April 13, 2020

### **Comments of the Joint Commenters on the Columbia River System Operations Draft Environmental Impact Statement**

NW Energy Coalition has prepared these comments on the Columbia River System Operations (CRSO) Draft Environmental Impact Statement (DEIS), which are supported by Idaho Conservation League, Natural Resources Defense Council, Sierra Club, American Rivers and Save Our wild Salmon Coalition, hereafter the "Joint Commenters."

**Figure 1-1 Analytical Approach for Evaluating Power and Transmission Effects of the CRSO Action Alternatives**

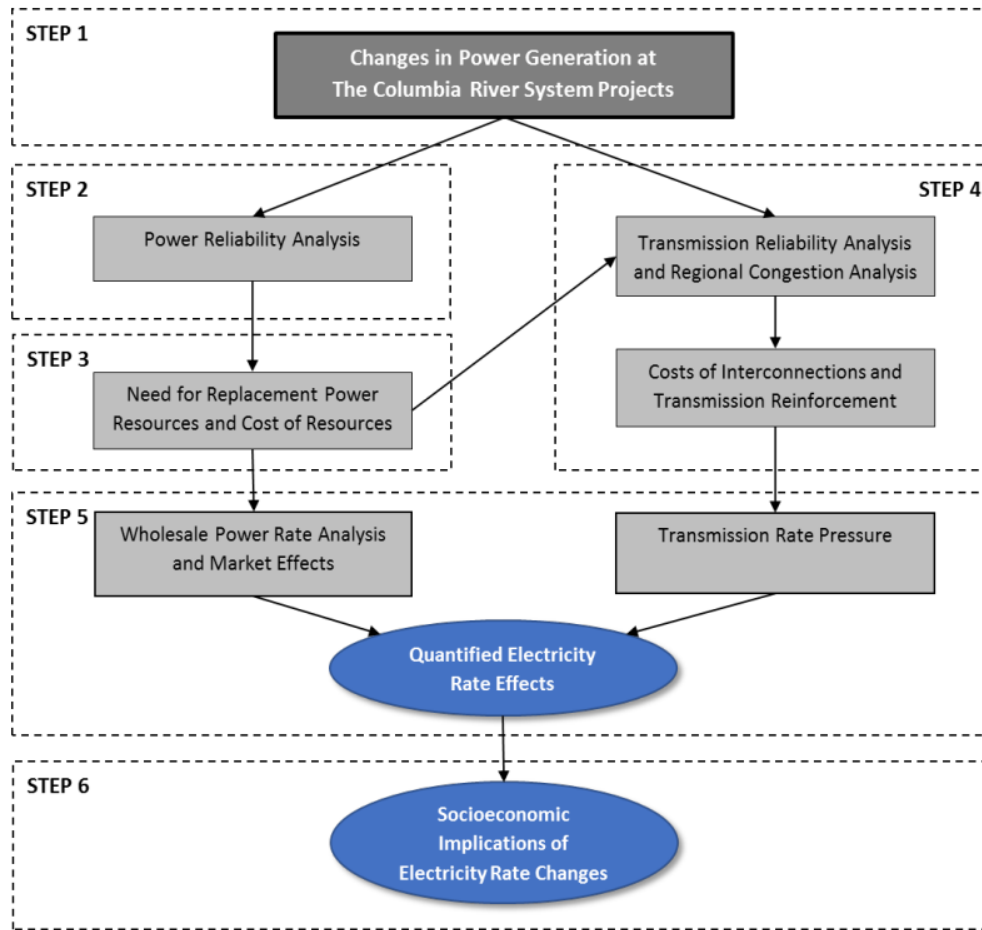
The DEIS energy analysis was conducted according to a multi-step process described in DEIS Appendix H, Section 1.1, Framework for the Analysis. The figure above indicates the basic analysis stages. The focus of these comments is primarily on Step 3, Need for Replacement Power Resources and Cost of Resources, referred to below as the “Replacement Power Analysis.”

Figure 3 - 7: Demand Response Resource Supply Curve

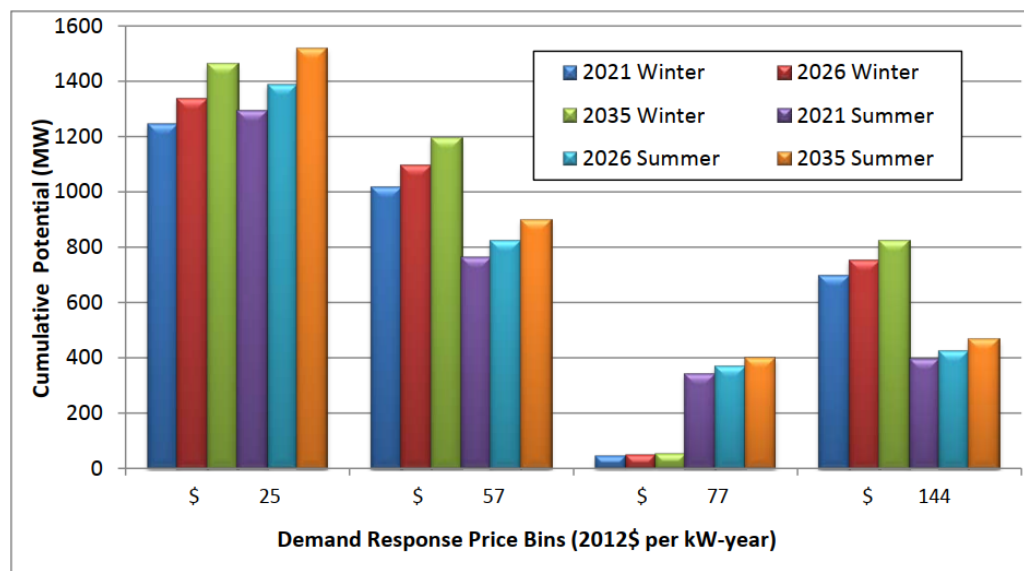
For example, as shown in Fig. 3-7 of the 7<sup>th</sup> Power Plan below, over 2,000 MW of cost-effective demand response is available in the 7<sup>th</sup> Plan at less than \$77/kW-year (2012\$), compared to new natural gas power plants at \$125/kW-year and above. 7<sup>th</sup> Plan, Table H-10, Frame Gas Turbine Cost Summary.

The DEIS does not include the full range of the demand response resource potential identified by the Council's 7<sup>th</sup> Plan, and does not provide an explanation for this omission. The failure to use accurate availability and cost for demand response resources means that,, especially for MO3, the DEIS Replacement Power Analysis increases the need for other more expensive resources, particularly battery storage, to address the capacity gap if the LSR hydrogeneration is retired.

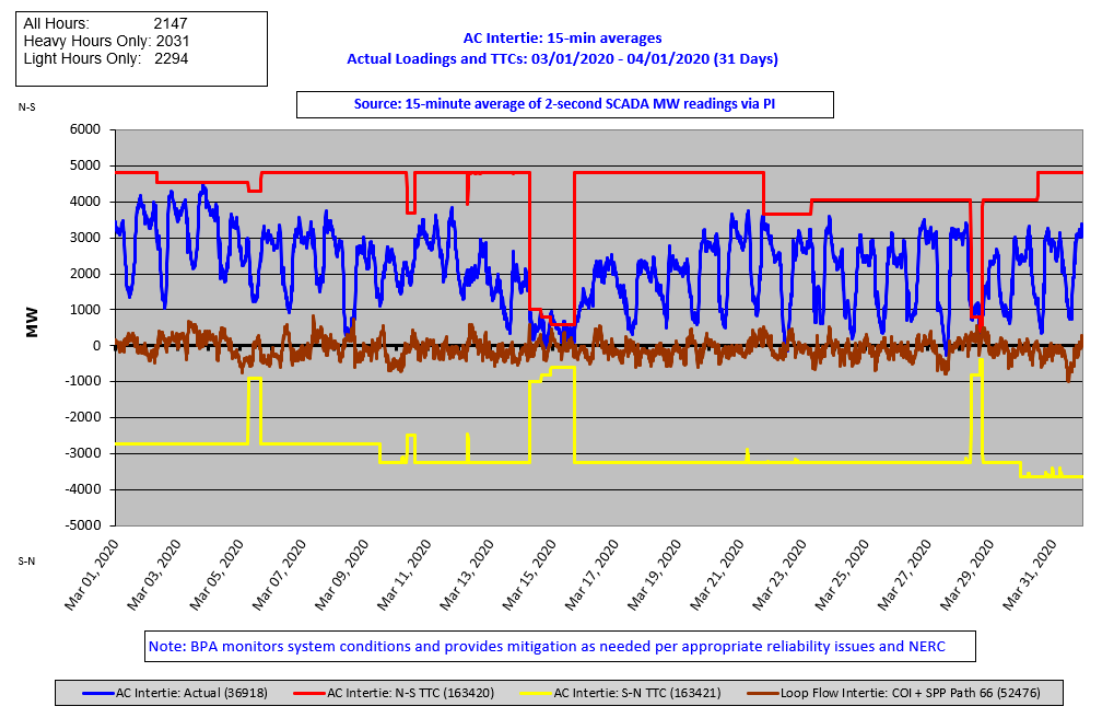
The chart above<sup>21</sup> illustrates these ongoing developments. It shows net power exports from the Northwest to California in March 2020 on the AC Intertie. The red trace shows North-South transfer capacity and the yellow trace shows South-North capacity, which vary when there are outages or planned maintenance on the AC Intertie system. The blue trace shows net exports. Over the last year, net imports to the Northwest – where the blue line goes below zero, have been occurring more frequently than in the past.
